1. The City of Yarra (Council) has prepared Amendment C231 to the Yarra Planning Scheme (Scheme), covering the Queens Parade Activity Centre and formalising the current Interim Controls introduced via Amendment C229 in February 2017 and Amendment C241 in August 2018. A Planning Panel Hearing is scheduled to start on 12 August 2019.

9. On 2 July 2019, I was engaged to prepare an Expert Witness Statement regarding urban design matters related to Amendment C231, with particular reference to the built form controls in the proposed DDO16. I am to consider two versions, the Exhibited Version and the Preferred Version prepared by Council and adopted on 28 May 2019 as its formal response to submissions.

Attachment 1: Exhibited & Preferred DDO16 / Initial Peer Review

Fig.7

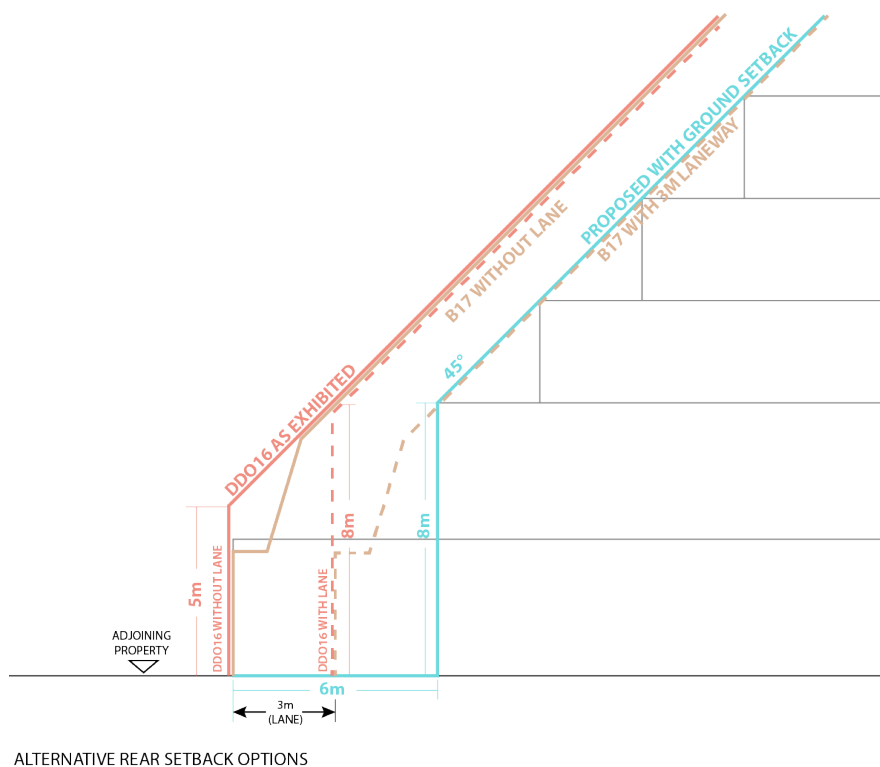
Even though the rear has a direct NRZ interface, the rear setbacks exhibited for DDO16 are not B17 but rather a wall height plus 45°. There needs to be consistency of approach between precincts, noting that the wall height plus 45° is simpler to implement. However, modelling shows the 5m or 8m interface to the rear (Hodgkinson Street) is challenging in terms of shadowing and visual dominance. I believe the sensitive interface would benefit from a ground level setback of at least 6m from the NRZ property boundaries (with the 6m including any existing laneway, such as 3m lane + 3m Precinct 3 setback). The rear Precinct 3 height would then start from 8m and proceed at a 45°

incline (Fig.7 shows in section the alternative rear setback options: Exhibited DDO16, Rescode R17 and my proposed 6m ground setback).

As can be seen from the different sections, there is no real difference between the Exhibited DDO16 controls and B17 when there is no laneway and an effective additional offset equal to the laneway width for B17 with a laneway. My proposed 6m ground level offset provides the same outcome with or without a laneway and is effectively equivalent to B17 with a laneway. This translates to a loss on each upper floor of 3m development depth compared to B17 without laneway but is the same as B17 with laneway. The top or fifth floor is still between 11m and 15m wide which is readily developable. It should also be noted that development depths greater than 18m will require some form of side setbacks or light courts to serve residential amenity.

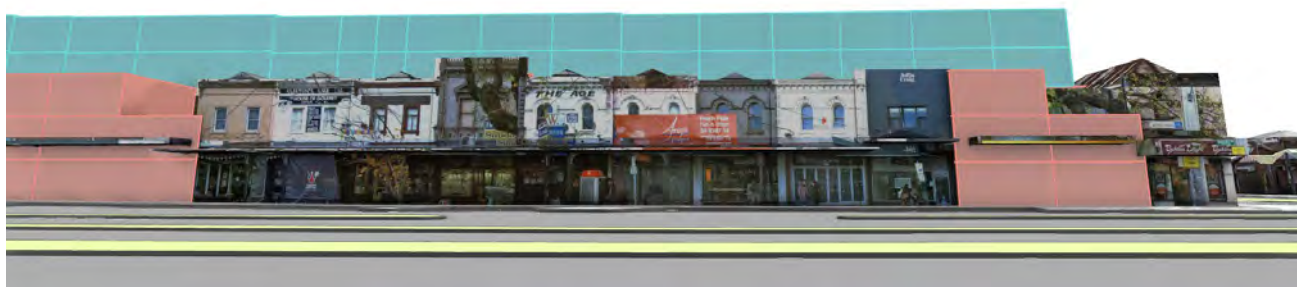
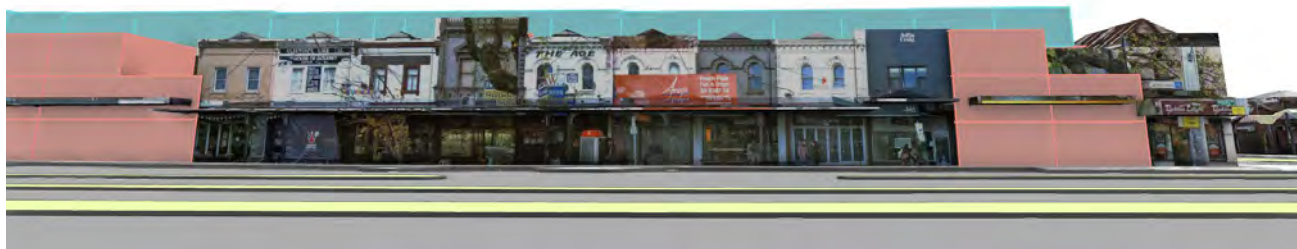
where the roof is deeper than 8m, a greater retention depth could still be sought especially for 'individually significant' heritage buildings and in some cases the roof might be cut short without undue heritage impact. The 8m setback should be mandatory, to provide continuous well-setback distinction from the frontages and avoidance of visible upper party walls (Figs.9 shows the DDO16-proposed 6m setback and Fig.10 show a continuous 8m setback).
